## **COMMERCE CENTER SUBDIVISION**

APPLICATION NUMBER 14 DATE September 20, 2007

REQUEST Subdivision

# DETAIL SITE PLAN

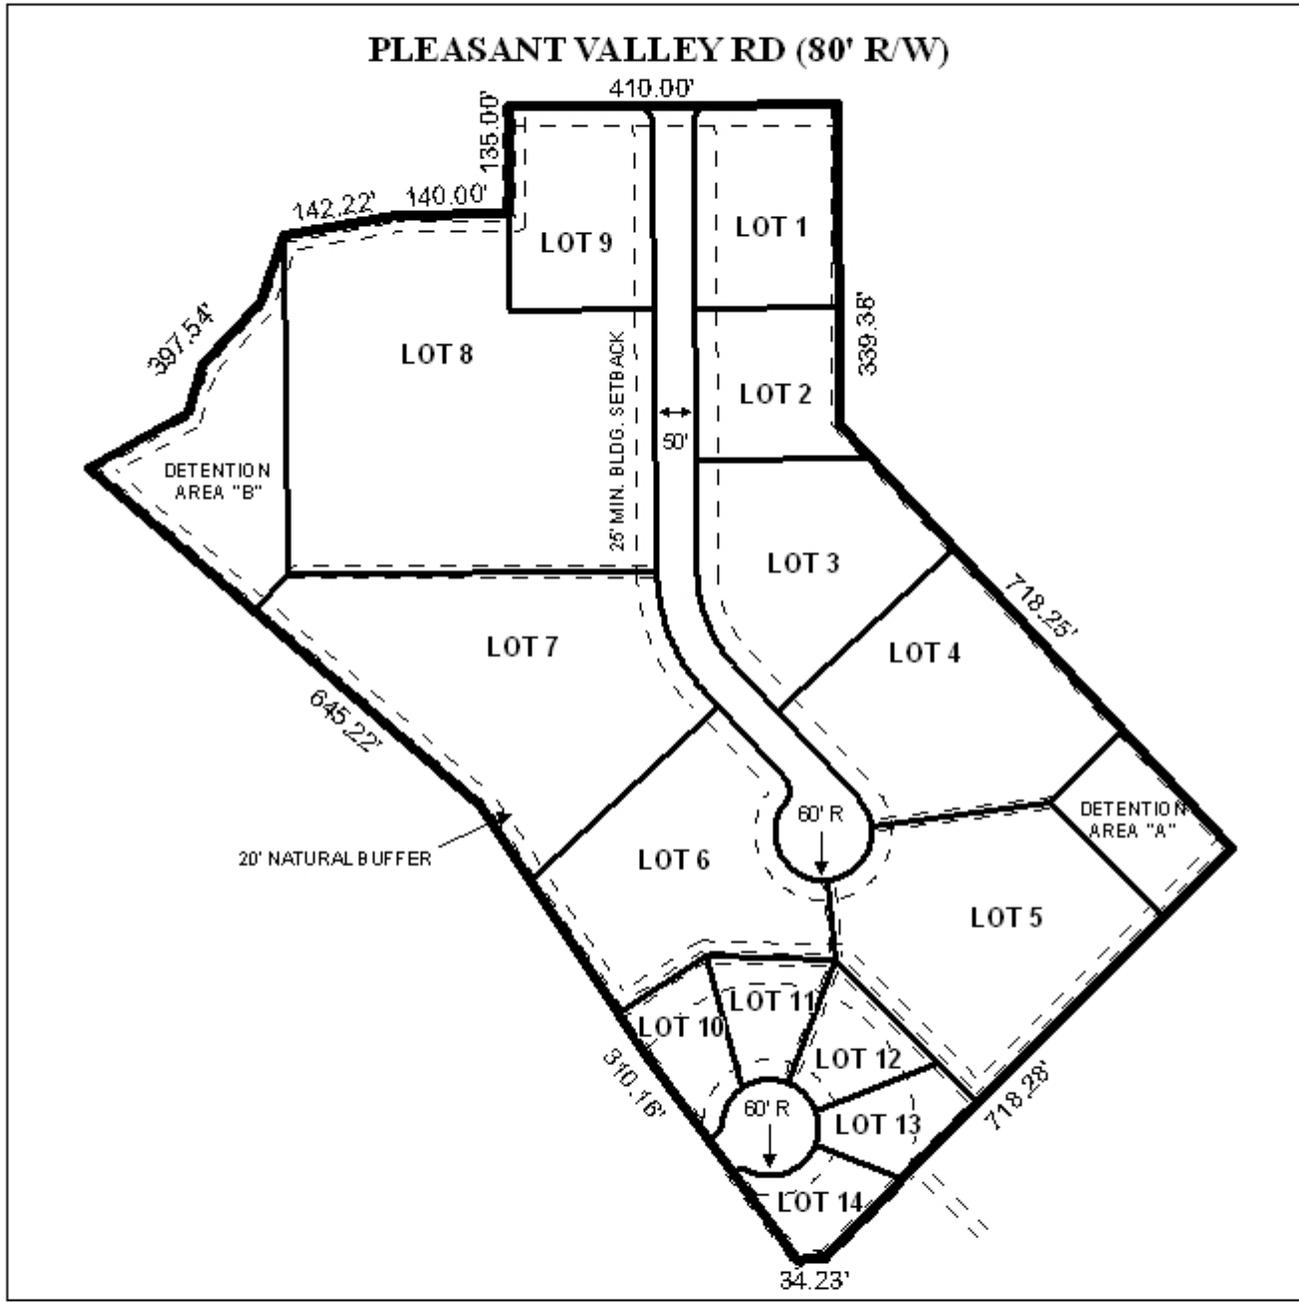
Access management would be a concern for Lots 1 & 9 as both front Pleasant Valley Road and provide less than 200 linear feet of street frontage; therefore Lots 1 and 9 should be limited to one curb cut each, with the size, location and design to be approved by Traffic Engineering and conform to AASHTO standards.

The preliminary site plan illustrates a 20-foot natural buffer for commercial lots adjacent to residential development; therefore, the illustration a 20-foot natural vegetative buffer should be required on the Final Plat.

Detention areas are depicted on the plat; therefore, a note on the Final Plat stating all common/detention areas will be maintained by the property owners association, and should remain on the Final Plat, if approved.

The proposed new street will exceed the maximum length of a closed-end street as recommended by the Subdivision Regulations; however, a waiver of Section V.B.6. would be recommended.

1. construction and dedication of the new streets to City of Mobile standards;
2. dedication of sufficient radii at the intersection of Pleasant Valley Road and the new street, with the size and design to be approved by Traffic Engineering and conform to AASHTO standards.
3. the depiction of the 25' minimum building setback line along all streets, as measured from the right-of-way line;
4. placement of a note on the final plat stating that all lots be limited to one curb cut each, with the size, location, and design to be approved by Traffic Engineering and conform to AASHTO standards;
5. the illustration of a 20-foot buffer to remain in a natural vegetative state on the Final Plat where commercial zoning abuts residential zoning;
6. full compliance with all municipal codes and ordinances; and
